Palo Verde Nuclear
Generating Station

102-05503-CDM/SAB/RJR
May 26, 2006

**SUBJECT: Palo Verde Nuclear Generating Station (PVNGS)
Units 2 and 3
Docket Nos. STN 50-529/530
Additional Information to Support the Request to Extend the Second
10-Year, American Society of Mechanical Engineers Section XI,
Inservice Inspection Program Interval for Reactor Vessel Weld
Examinations – Relief Request No. 34**

**Relief Request No. 34 – Additional Information Addressing the Accident
Sequences Identified by the NRC during its Re-evaluation of the Risk from
Pressurized Thermal Shock (PTS)**

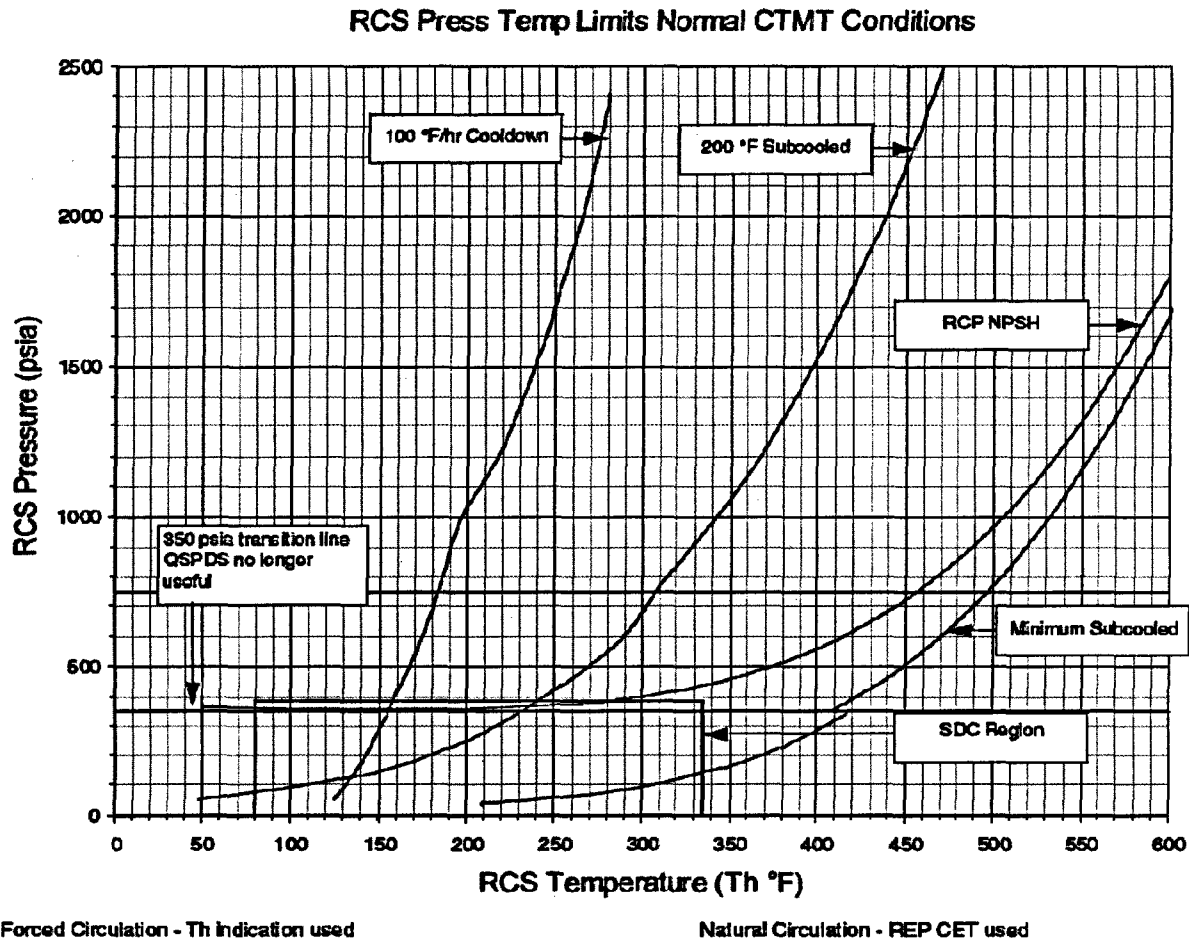
Large loss of secondary steam from steam line break or stuck-open atmospheric dump valves. Severe PTS events also require the failure to properly control auxiliary feedwater flow rate and destination (e.g., away from affected steam generators) and failure to properly control high pressure injection.

Initially, the control room personnel complete procedure 40EP-9EO01, "Standard Post Trip Actions." The Operating staff would then enter 40EP-9EO05, "Excess Steam Demand," (ESD). The goals of this procedure are to mitigate the effects of an ESD, maintain the plant in hot standby, or hot shutdown (if the break has been isolated), or to establish Shutdown Cooling System entry conditions while minimizing radiological releases to the environment and maintaining adequate core cooling. 40EP-9EO05 includes the following guidance in Step 14 which is performed after isolating the most affected Steam Generator, including stopping auxiliary feedwater to the faulted SG:

14. Stabilize RCS temperature using the lowest Tc by performing the following:
 - a. Maintain Tc within the P/T limits.
REFER TO Appendix 2, Figures
 - b. Steam the least affected Steam Generator using **ANY** of the following:
 - SBCS
 - ADVs from the Control Room
 - Appendix 18, Local ADV Operation

Stabilizing Tcold within the Pressure/Temperature (P/T) limits precludes PTS. EOP 40EP-9EO05 also contains the guidance for throttling HPSI when throttle criteria are met (same as Step 27 from LOCA). EOP 40EP-9EO10, "Standard Appendices," contains all of the figures, tables, charts, graphs and sub-procedures associated with performance of the EOPs.

Appendix 2 of 40EP-9EO10 shows the acceptable areas of operation and delineates where PTS becomes a concern (the 200 degree subcooled line). Appendix 2 is provided below:
